**STAFF REPORT**

**CASE NUMBER:** P.D. 08-335      **L.U.C.B. MEETING:** January 8, 2009  
**COMPANION CASES:** SAC 08-613 and 614

**DEVELOPMENT NAME:** Lakeview Estates Planned Development

**REQUEST:** Housing for Seniors (100 units in one 3-story building)

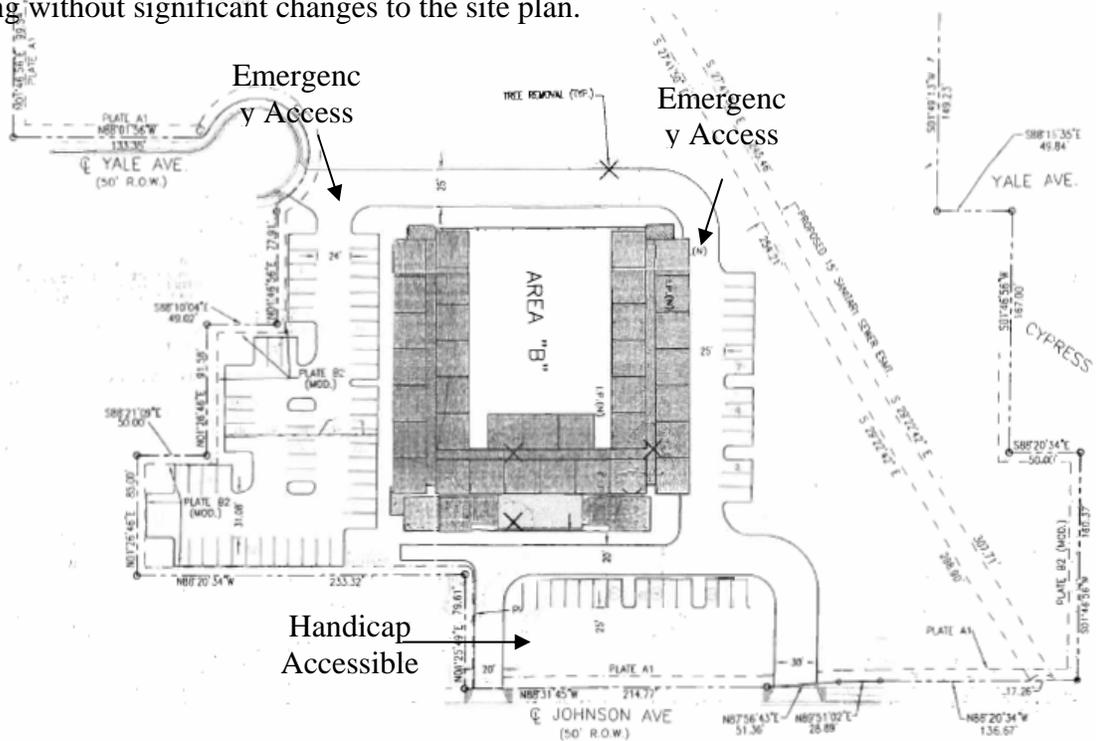
The Site Plan – While the staff supports the requested redevelopment of this site, it cannot enthusiastically support the site plan as it is currently drawn. The proposed 3-story building has an internal orientation that does not connect it visually to the neighborhood. As drawn, this building and its occupants will be separated from the larger community, much like most apartment complexes which operate with no connection to the greater community.

As an alternative, the staff recommends turning this building approximately 90 degrees to face Johnson Avenue. The porte cochere and limited parking could be continued between the building and the street and there is enough space to accommodate a small green area between the parking and the sidewalk. This will present a front rather than a side view to the public and

provide a direct route for the occupants to Johnson Street which is on a designated MATA bus line. The applicant has submitted an elevation of the front of the building which is very attractive and deserves to be shared with the rest of the community. Beyond aesthetics, well designed, attractive buildings signal reinvestment into a community.

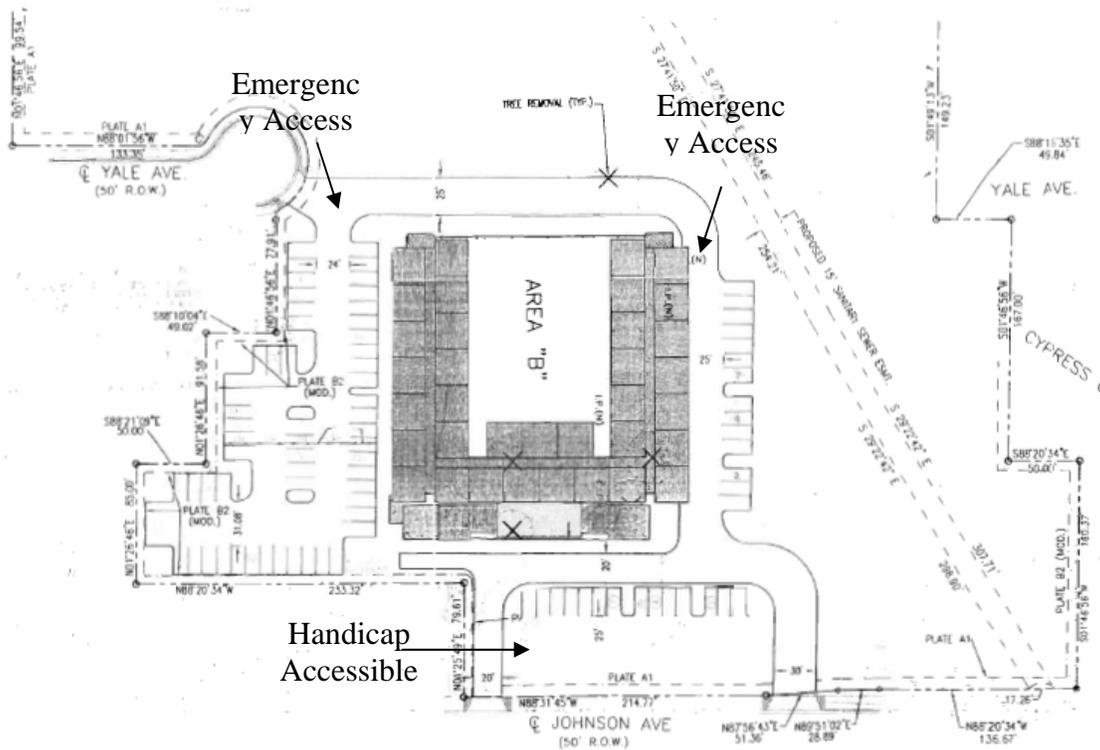
While a residential home for the aged is consistent with the existing character of the neighborhood, the building orientation depicted on the site plan accompanying the case application should be reconsidered. Changing the orientation of the building to front

Johnson Avenue would better integrate the building with the rest of the neighborhood and be consistent with the proposed land use depicted in the “Midtown Corridor East Binghampton Plan” (adopted in 2004). An orientation similar to that depicted in the diagram below is one alternative to the existing plan.

Handicap accessible parking should be located at the front of the building and there should be emergency service access located at the rear of the building. Further, the proposed building relationship to the street and surrounding context could potentially emulate several local examples: 1) The Parkview, adjacent to Overton Park, on Poplar Avenue 2) University Place (formerly Lamar Terrace) and 3) The Village, located at the intersection of Park and Cherry in front of Harding Academy.
